ADDENDUM #2

C20004 – US 101/BLOSSOM HILL ROAD INTERCHANGE IMPROVEMENT

ISSUE DATE: APRIL 16, 2020

Sheet 58 – Drawing C-39 Construction Details

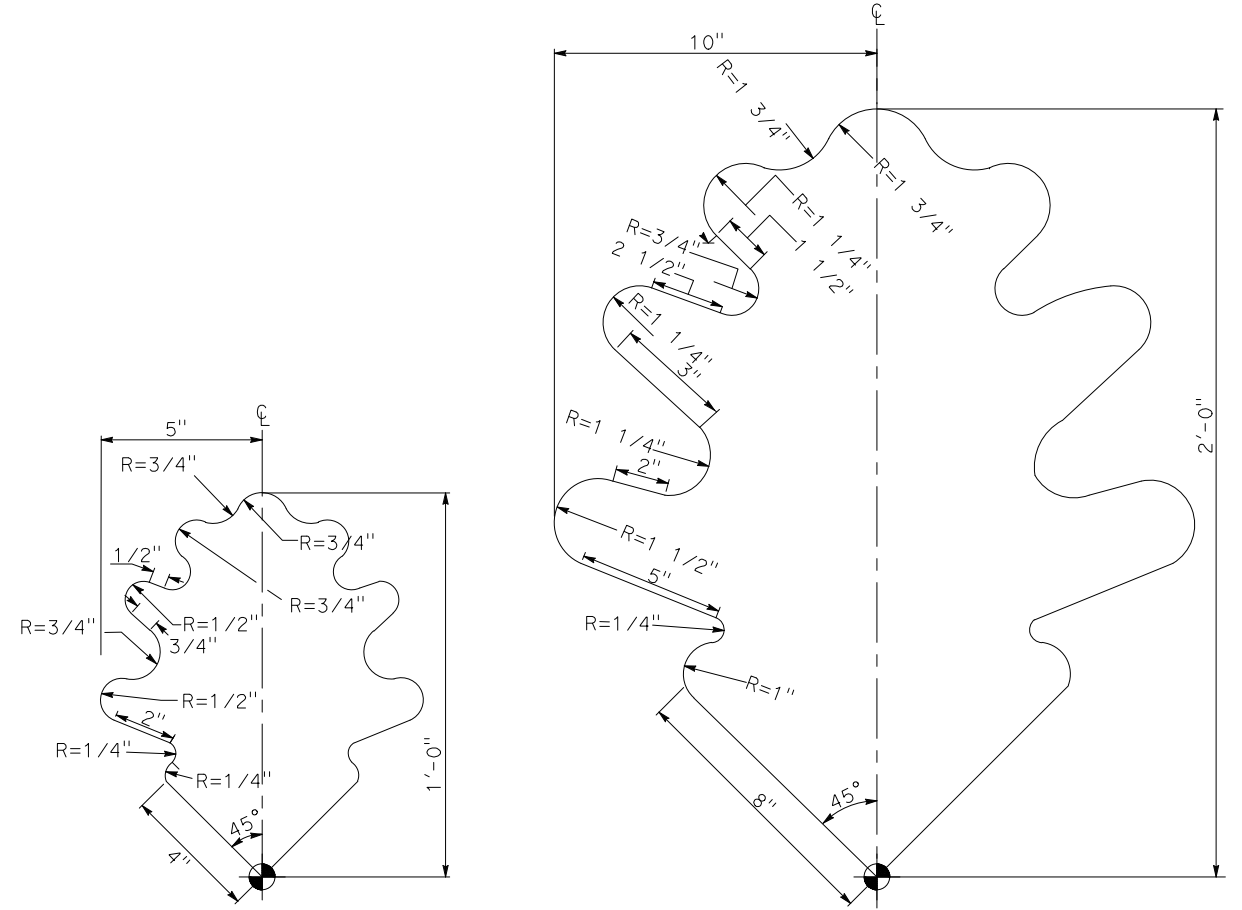
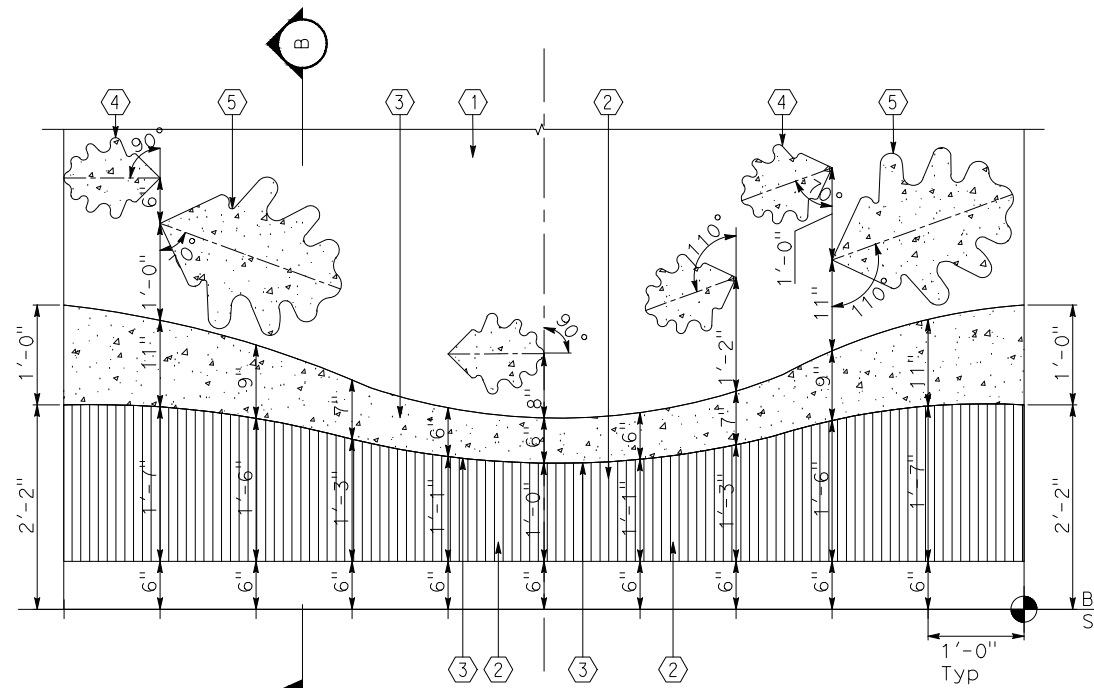
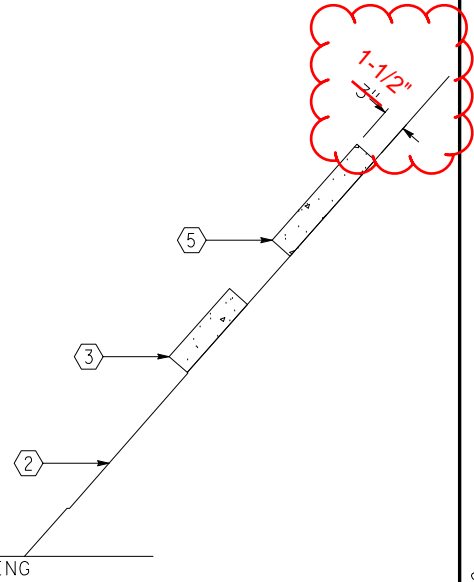
4. **REPLACE** drawing C-39 with the attached revised drawing C-39
